Service Bulletin

Subject: FRONT POWER SEATS DO NOT SLIDE BACK AND FORTH	Bulletin No: 09-006/16
	Last Issued: 02/03/2016

2013-2016 CX-5 vehicles with VINs lower than JM3KE*****663237 (produced before May 1, 2015)

2014-2016 Mazda6 vehicles with VINs lower than JM1GJ*****430009 (produced before May 1, 2015)

Power Slide Unit

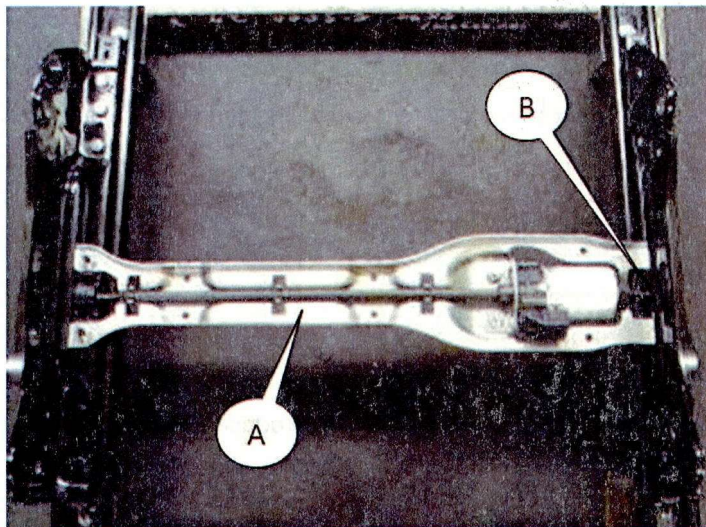
Some customers may complain that the front power (driver and/or passenger) seats do not slide back and forth properly or that they may be completely inoperative. This concern may be caused by a foreign object getting stuck under the power slide unit (below) while in operation. This can cause motor mounting bracket (A) deformation, resulting in motor cable (B) breakage.

To eliminate this concern, the shape of the motor mounting bracket (A) has been modified to increase its strength.
